Consumers
Power
Company

MIDLAND PROJECT - ALAB-106 MONTHLY REPORT FOR FEBRUARY 1982
DOCKET NOS 50-329 AND 50-330
FILE: 0.4.6 SERIAL: 16145

In accordance with Condition of Memorandum and Order ALAB-106, dated March 26, 1973, and Amendment No 1 of the Midland Plant Construction Permit, enclosed are ten copies of the following documents written or closed during the month: Bechtel Nonconformance Reports; sheets from the Bechtel Nonconformance Report Log; Bechtel Quality Action Requests; Bechtel Management Corrective Action Reports; Bechtel Quality Assurance Findings; Bechtel FLAGS Quality Action Requests; Babcock & Wilcox Reports of Nonconformity; Babcock & Wilcox In-Service Inspection Nonconformance Reports; Consumers Power Company Nonconformance Reports; Audit Finding Reports; Quality Action Requests; Corrective Action Reports; and Management Corrective Action Reports.

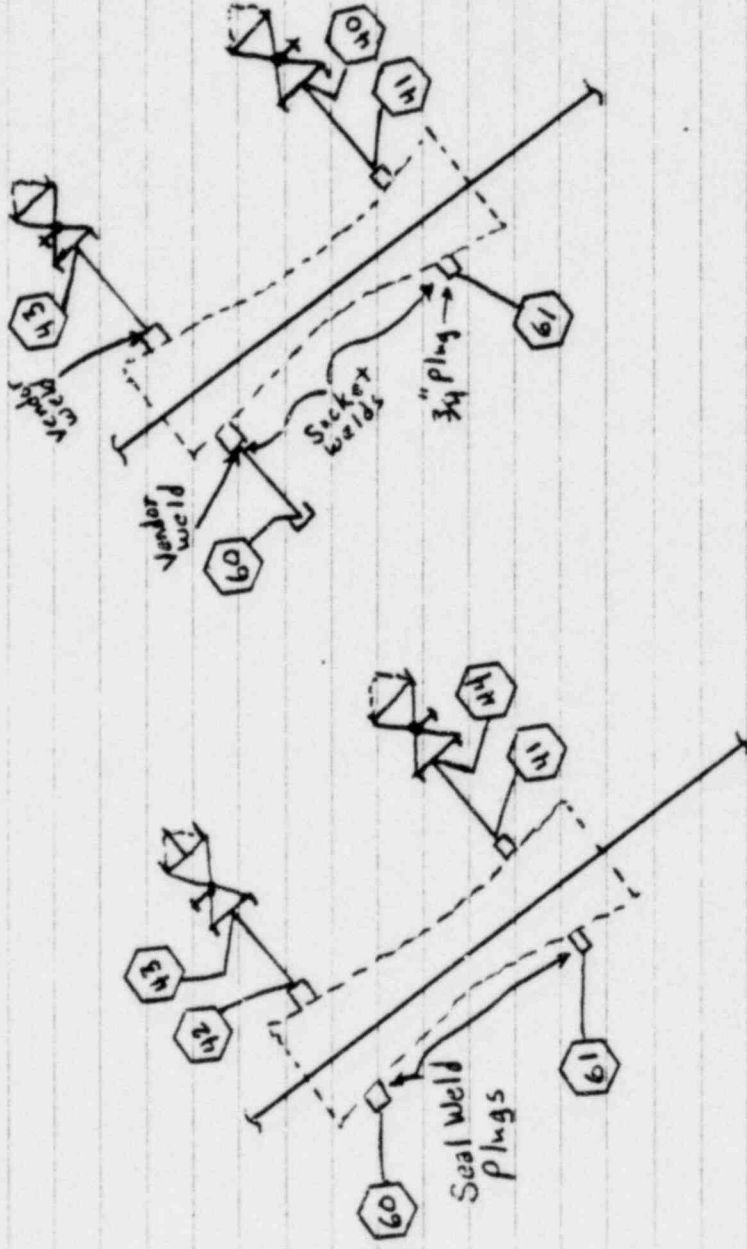
Block 16 Cont. Does Not exist the weld indicated as S.W. #42 is actually a Vendor weld. S.W. #44 does not exist. The weld indicated on DWG is actually S.W. #40. S.W. #60 and S.W. #61 were installed without Q.C. verification or documentation of cleanliness prior to installation.
See sketch below.

NCR 3959

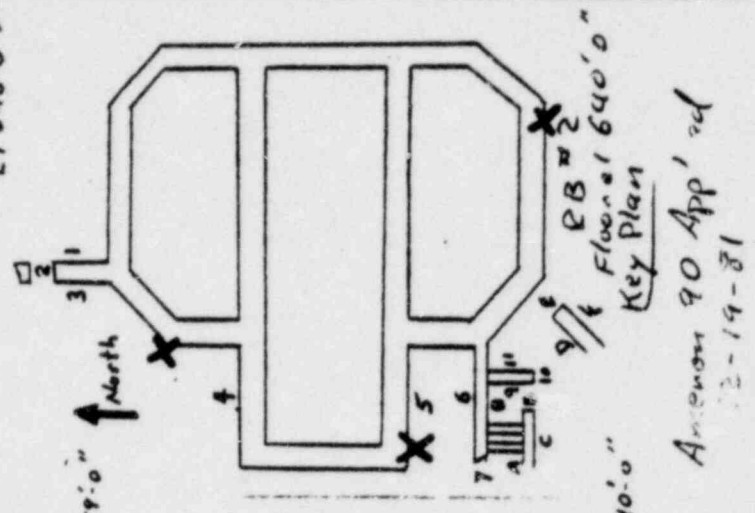
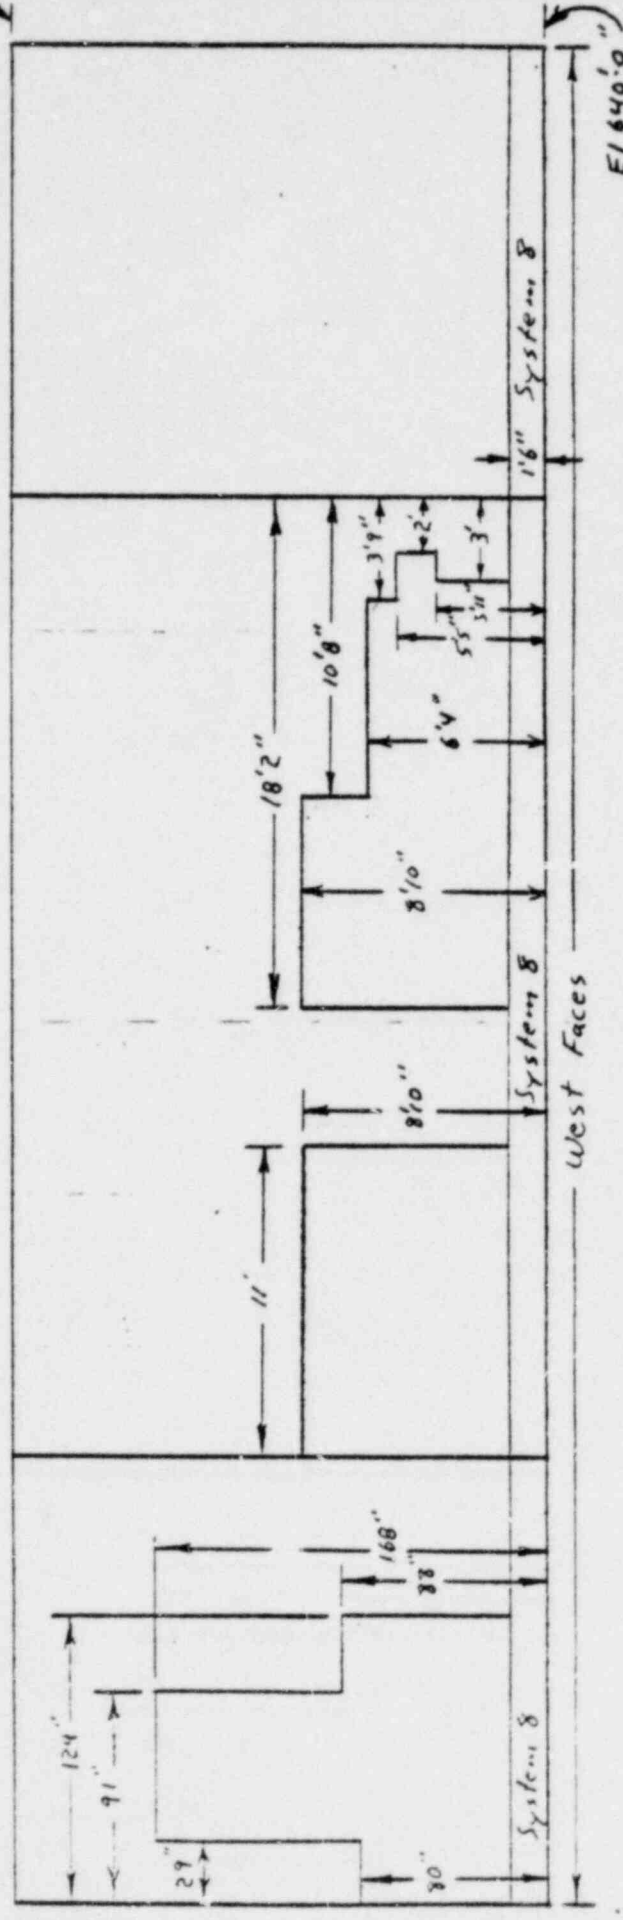
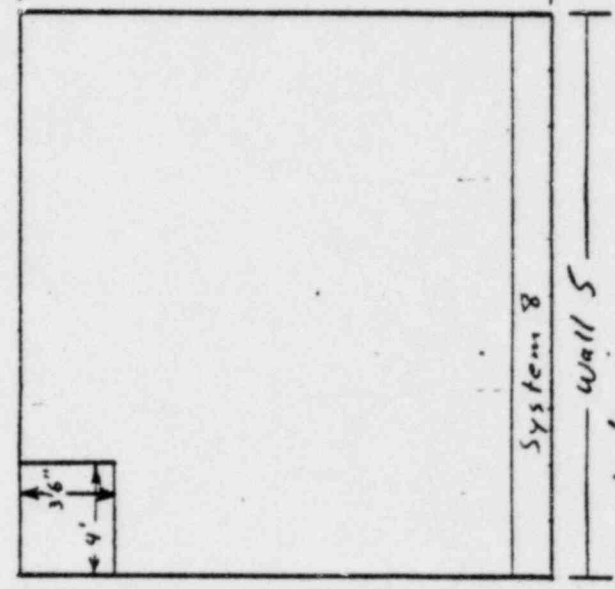
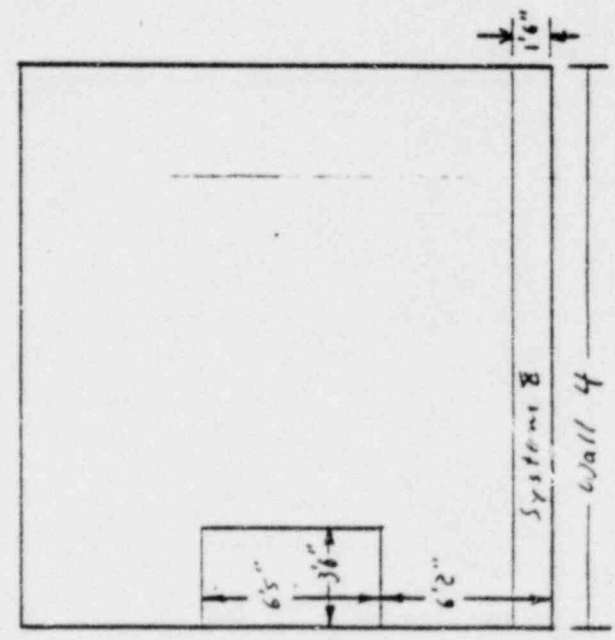
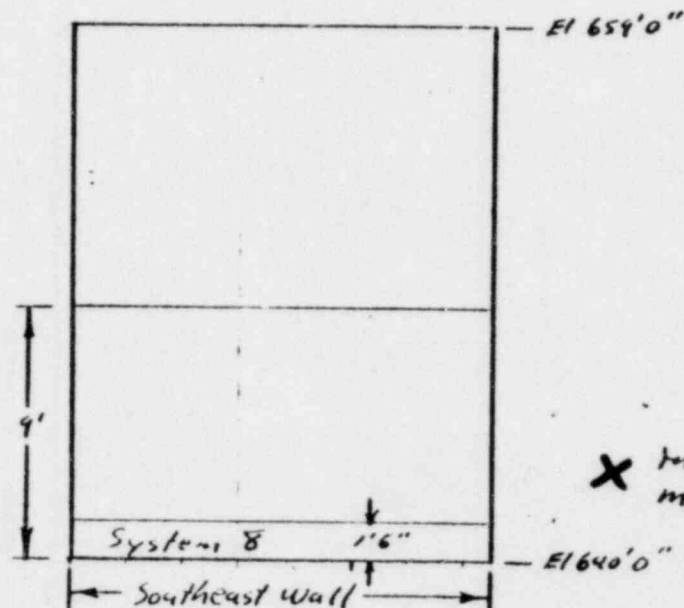
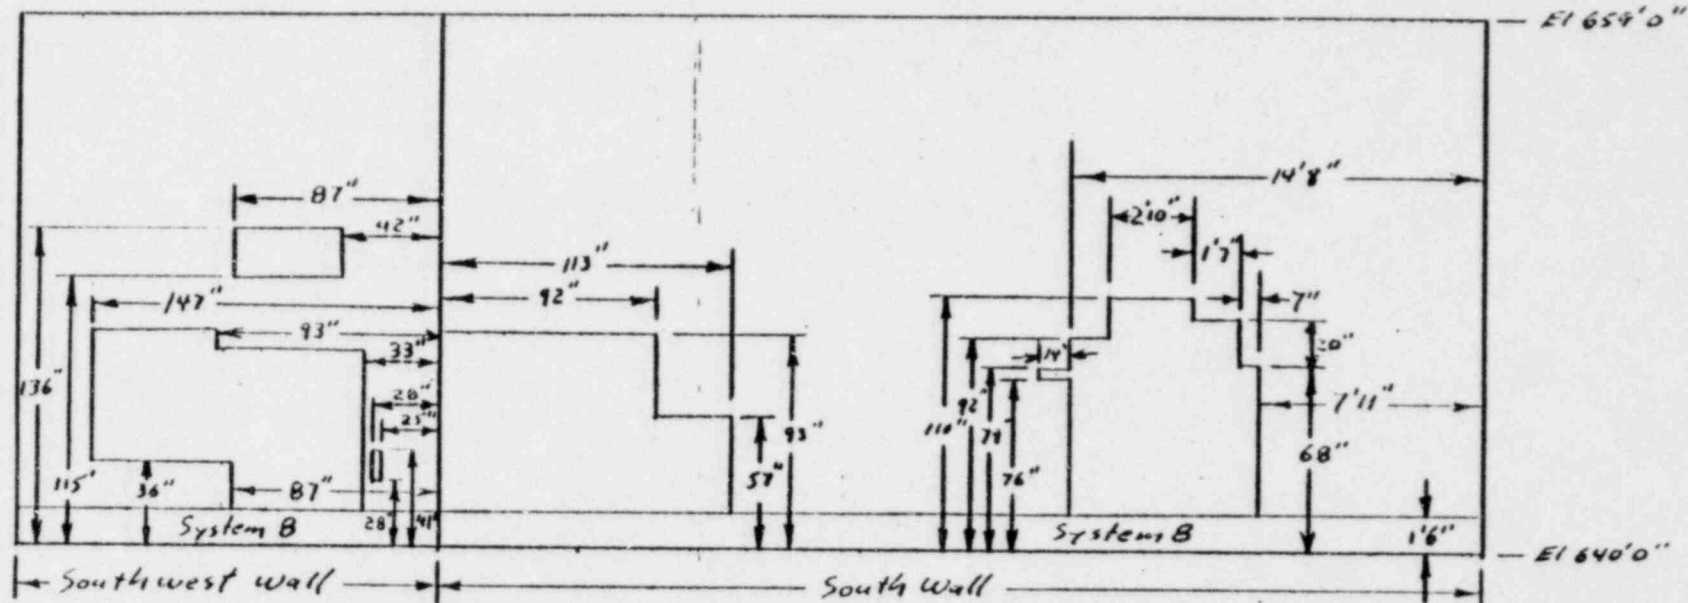
Indica's curve
monitor location

X indicates cure monitor location

23. PROJECT ENGINEERING DISPOSITION							
24. DISPOSITION CONCURRENCE							
rework		reject		repair		use as is	
PROJECT FIELD ENGINEER		PROJECT ENGINEER		PROJ CONSTR QC ENGINEER		AUTHORIZED INSPECTOR	
DATE		DATE		DATE		DATE

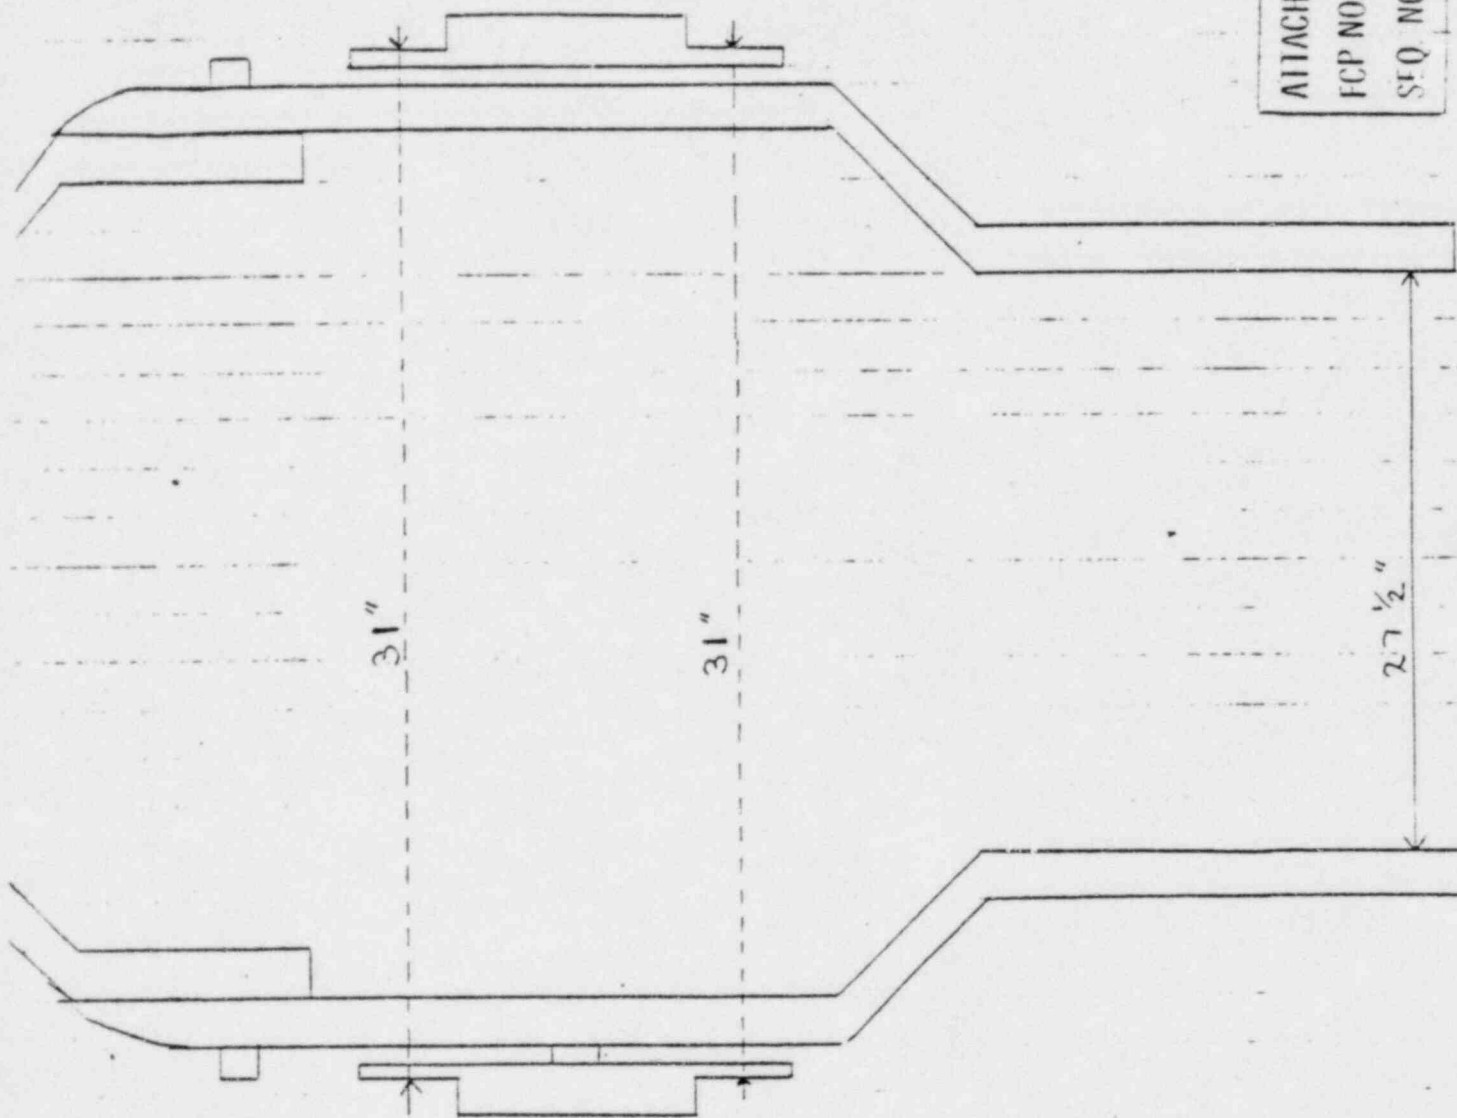
9. PROCEDURE NUMBER FCP #406
10. SPECIFICATION NUMBER N/A		11. DRAWING NUMBER 22595-33, Rev. E		12. PRIOR REPORT OF NONCONFORMITY N/A
13. DESCRIPTION OF NONCONFORMITY During placement of the carriage on the fuel transfer rails, it was noted that the 5th set of wheels (counting east to west) would not fit on the rails. Subsequent investigation revealed revealed that the dimension, wheel flange to wheel flange is 32 1/4", the required dimension, per referenced dwg. is 31". A frame dimension was also noted to be incorrect, relative to the referenced dwg. The dwg. requires a dimension of 27 1/4" frame to frame, the dimension measured on the frame was 28 3/4". This measurement was taken at the 5th set of wheels, referred to above. See attached attached dwg., not to scale.

Discussed with Ralph Gordon

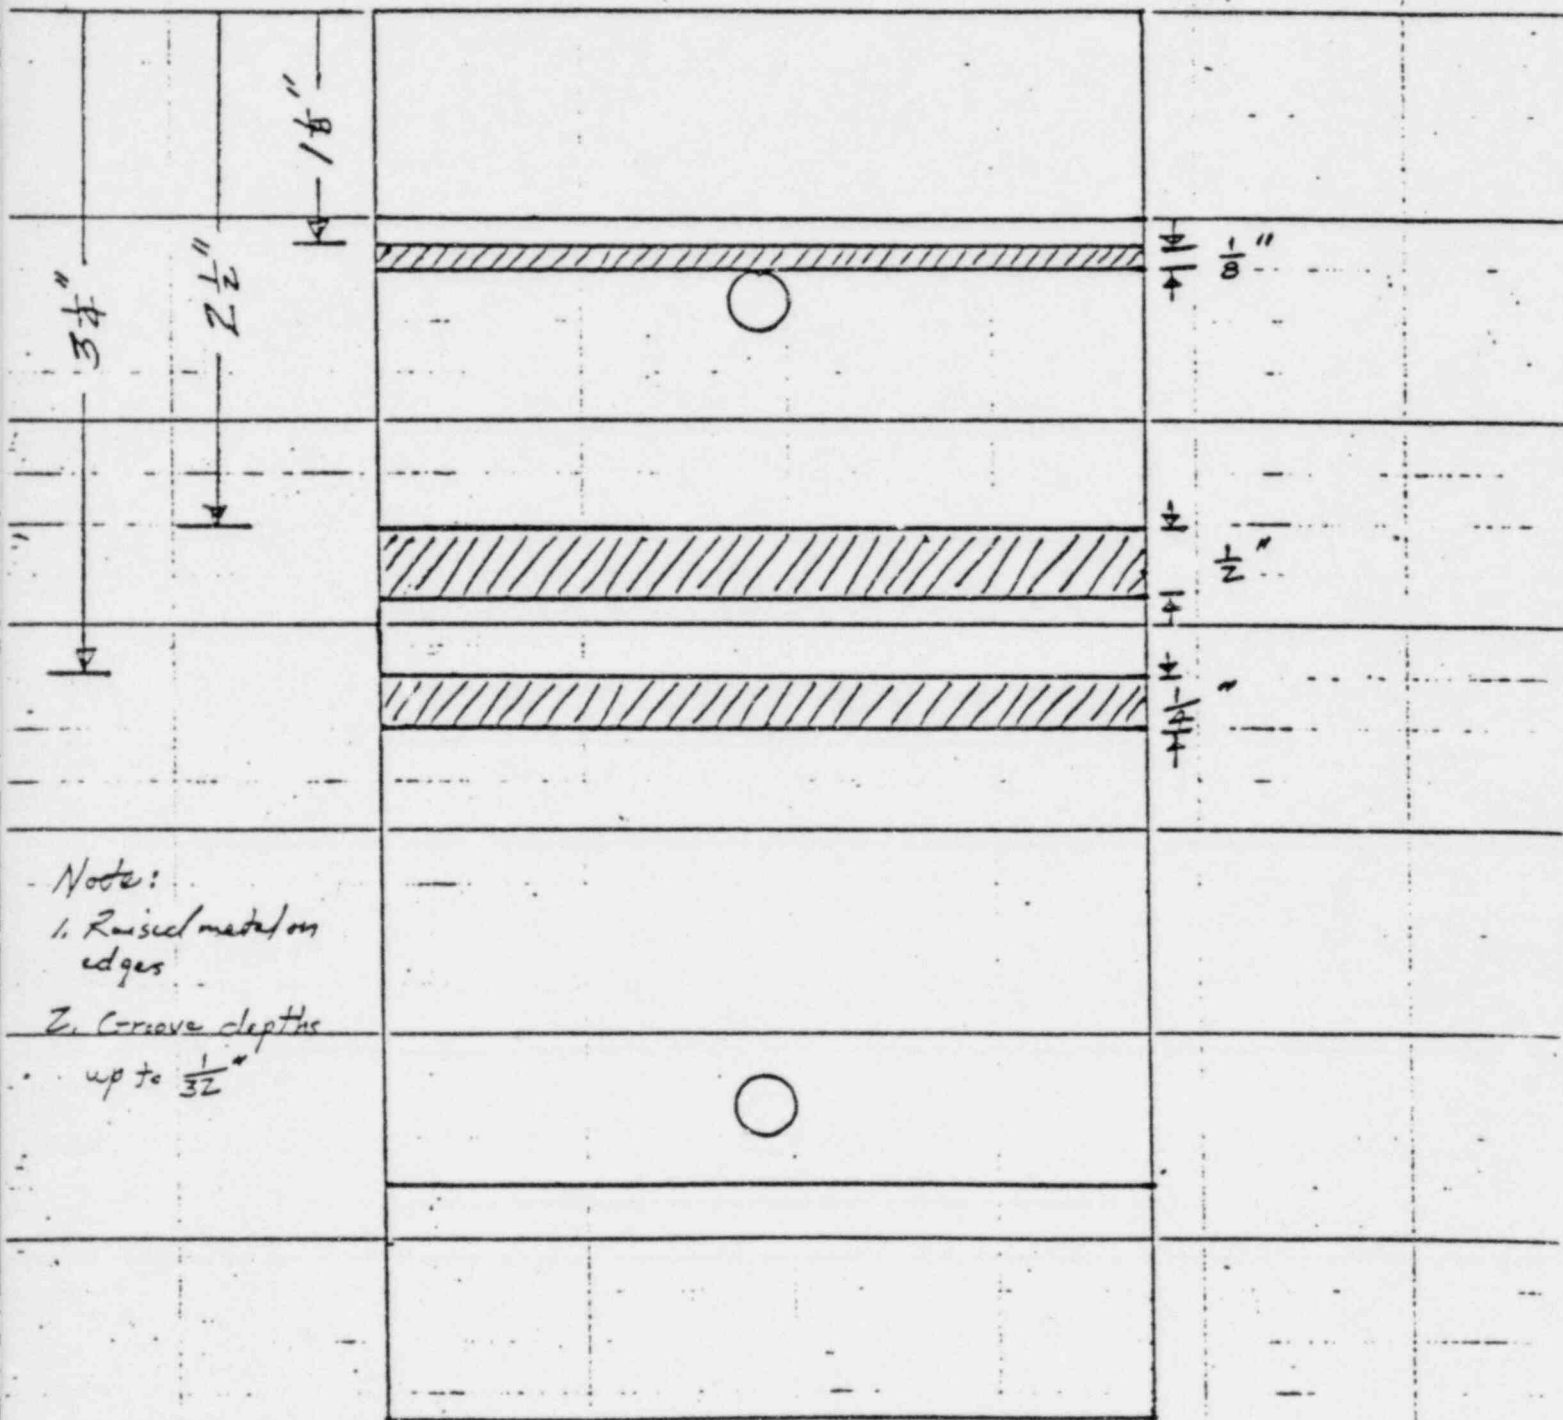
Note:
1. Raised metal on edges
2. Groove depths up to 1/32"

6. Handwork to remove all raised metal and to break all corners on the thrust runner.

East Oil Scraper

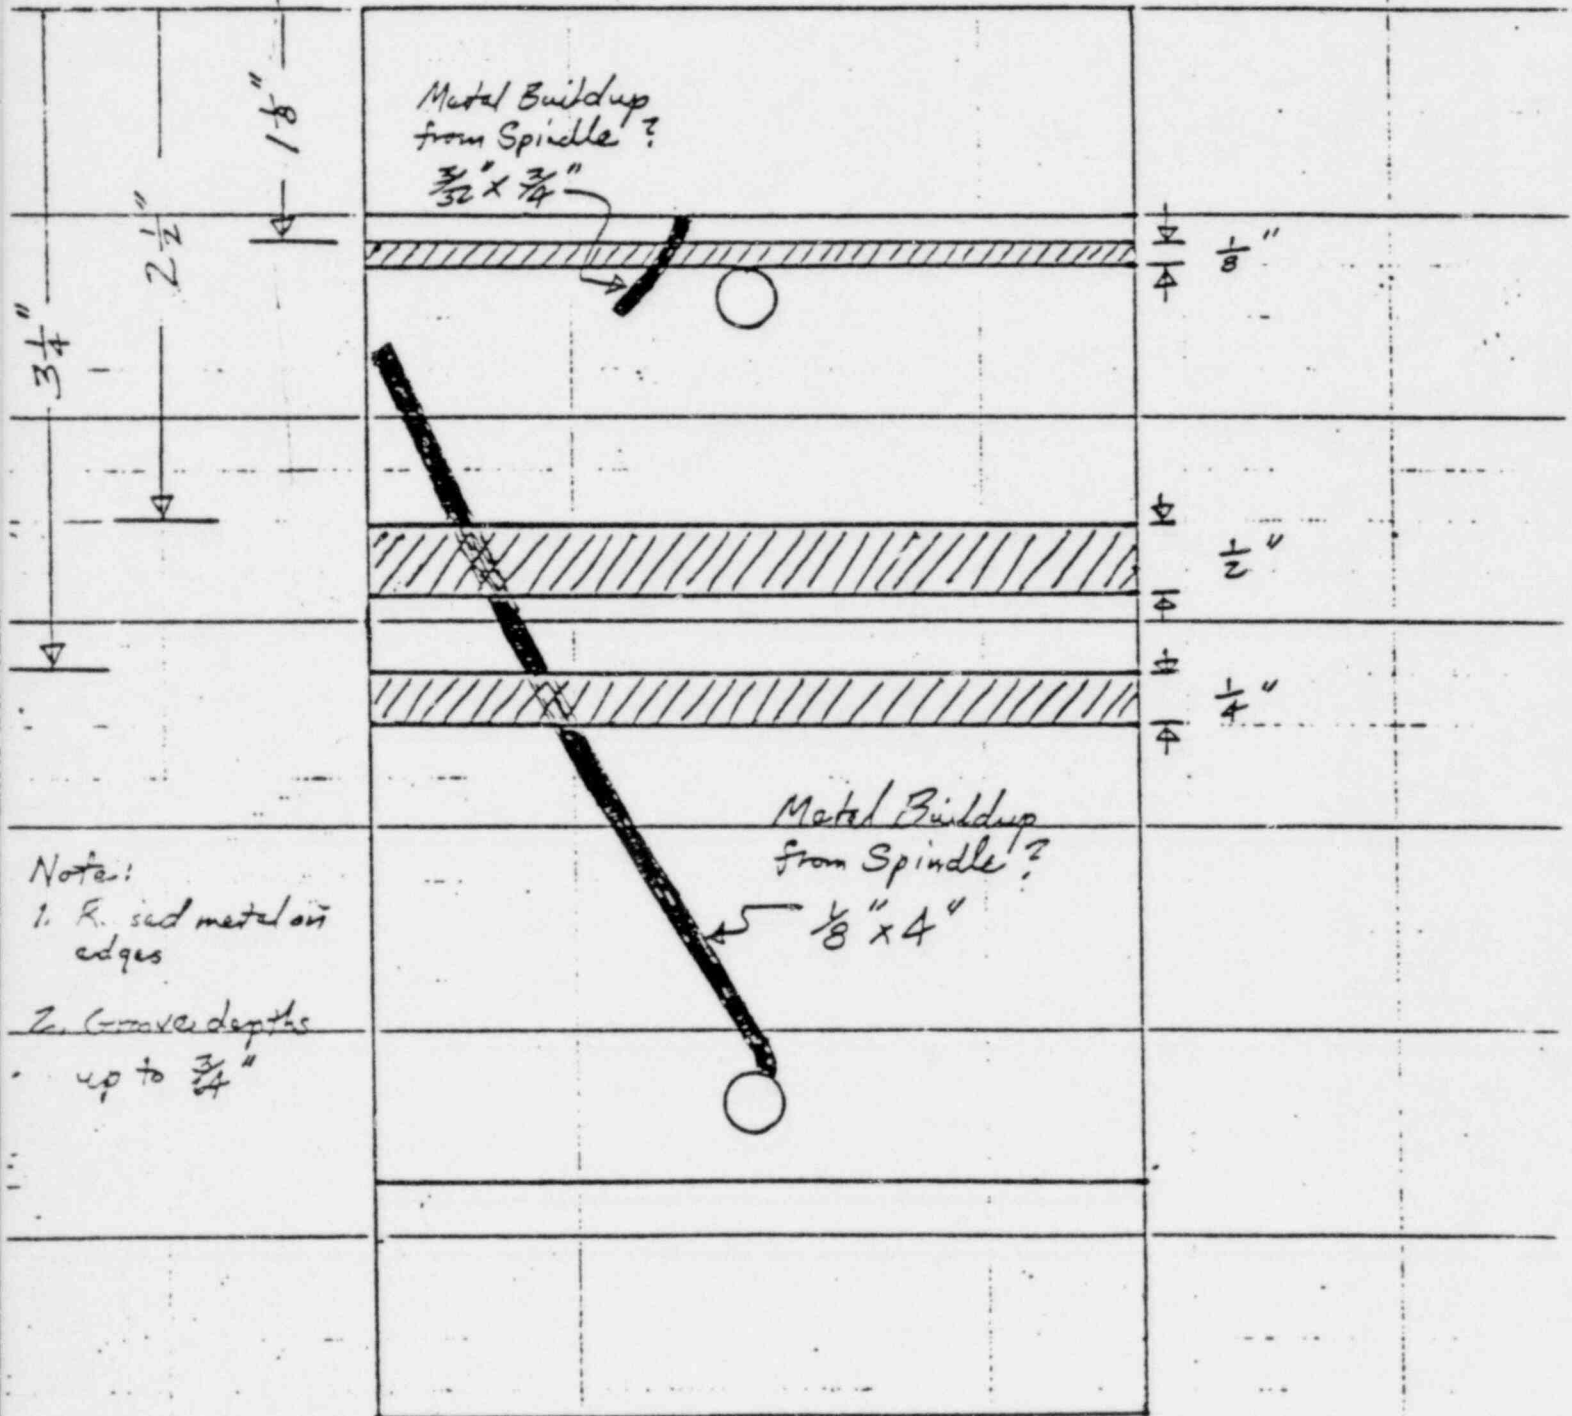
- Notes:
1. R. side metal on edges
 2. Groove depths up to 3/4"
